ISSUE: Certificate of Appropriateness for alterations

APPLICANT: Fish Market/Dewey Investment Associates

LOCATION: Old and Historic Alexandria District
105-107 King Street

MOUNTING DETAIL

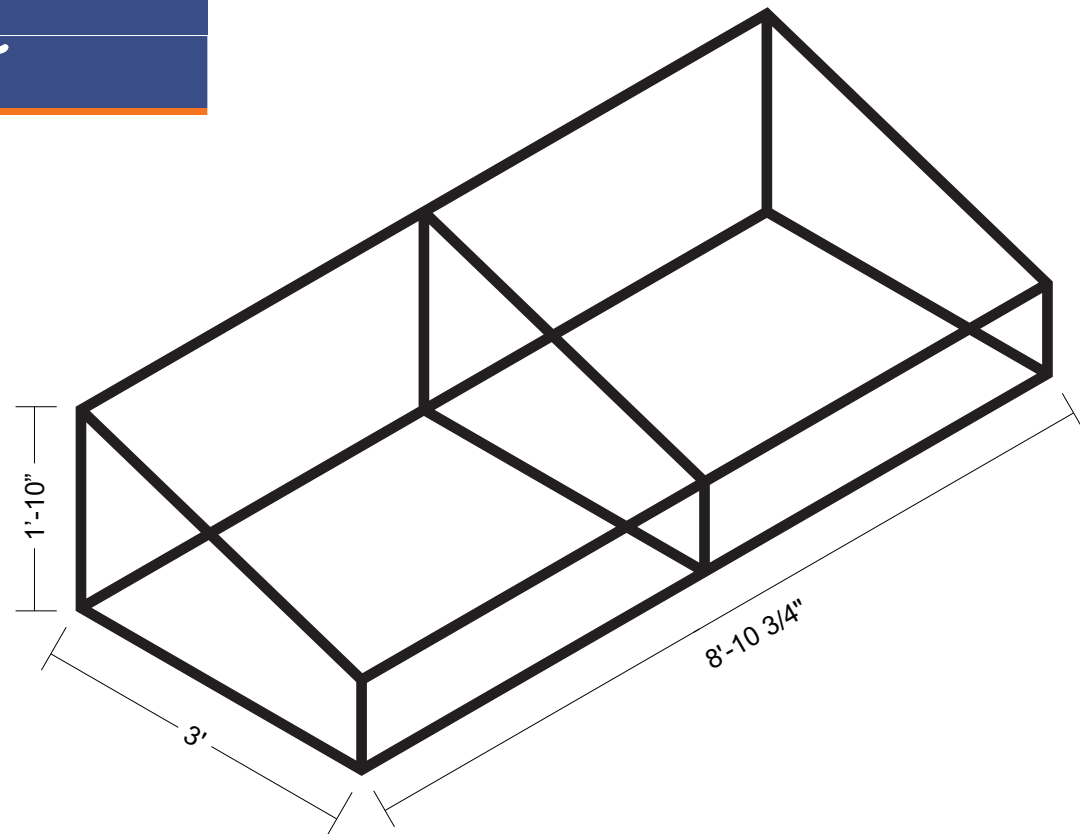
1. Reduce the width of the awning by approximately four-to-six inches on either side, so as not to overlap the jack arches on the adjacent openings; and,
2. Install the awning hardware through the mortar joints and not the brick.

The applicant now seeks to add a similar awning over the first-floor doors to the outdoor seating at the Fish Market in order to visually unite the two buildings that the restaurant occupies. The applicant has worked with staff to design a simple, compatible, shed form awning that unifies the two storefronts. Staff recommends that the awning be reduced in width by approximately four-to-six inches on either side so as not to crowd the brick jack arches over the adjacent storefront windows.

Staff also notes that the awning hardware should be installed into the mortar joints and not the masonry units per the *Design Guidelines*.
